Independent External Peer Review: Final Construction Site Visit Summary Report

Hurricane and Storm Damage Risk Reduction System (HSDRRS) Gulf Intracoastal Waterway (GIWW) West Closure Complex (WCC)

Prepared by
Battelle Memorial Institute
505 King Avenue
Columbus, OH 43201

December 22, 2011

Figure 13. Pump station precast concrete wall panels do not sit on a uniform top of cast-in-place elevation

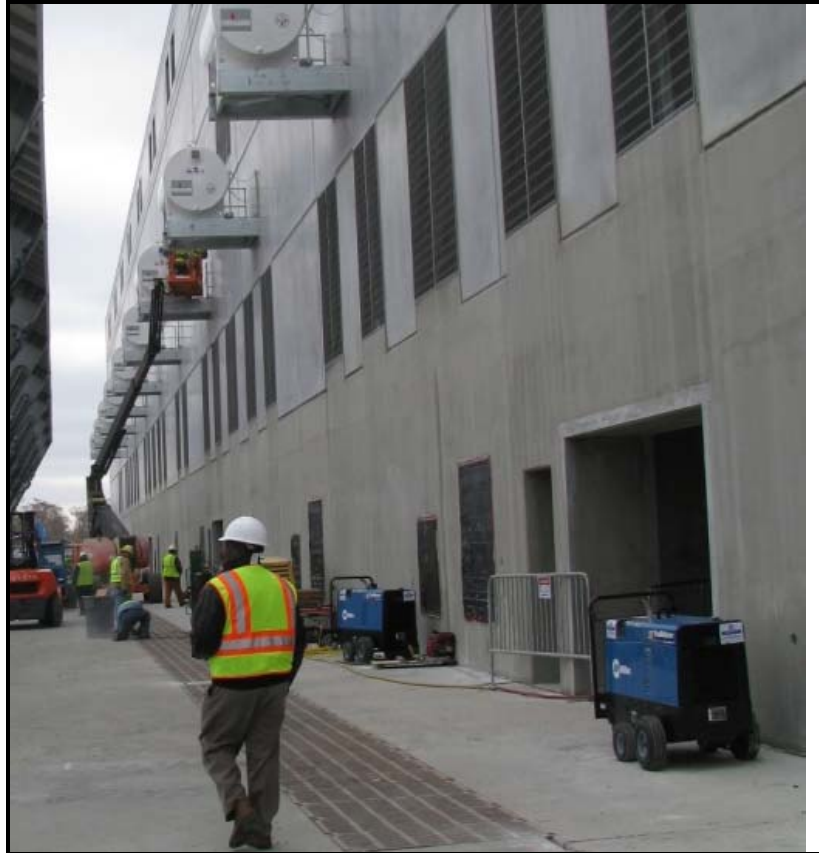
- **Pump station exterior precast panels:** The Panel questioned why the external precast panels on the pumping station walls did not start from a uniform elevation (Figure 13) at the top of the cast-in-place pours. The notched cast-in-place concrete may cause cracking at the interior corners, a minor amount of which had already been observed. The PDT did not know for sure why the concrete was detailed that way, but the final sizing of the louvers and the impact of rework to change the cast-in-place top elevation and precast panel sizes were likely the reasons. Consensus between the PDT and the Panel was that any cracking was likely to be minimal and not require any changes. The Panel also commented on the sound appearance of the precast panels.

Figure 46. Thickened section of riprap recommended for both the upstream and downstream ends of the rip

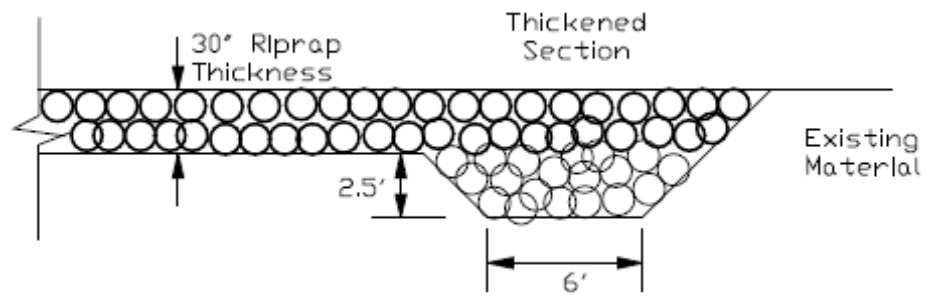
Although not tested, the downstream end of the riprap should be terminated with a thickened section to insure stability of the downstream end of the riprap. Figure 46 shows a thickened section that should allow at least 5-ft of scour at the downstream end of the riprap. While the 24" maximum stone size riprap in the model (increased to 30" due to unit weight and 3D effects) was stable, the area just downstream of the slab is the primary point of possible instability that could cause problems to the structure if it were to fail. Riprap is not a uniform material and thus has the possibility of certain areas having primarily the small rocks in a gradation. ERDC recommends that this possibility be handled by also using the thickened section at the upstream end of the riprap where it abuts the concrete slab. On the upstream end, the full 5-ft thickness of the thickened toe would abut the downstream face of
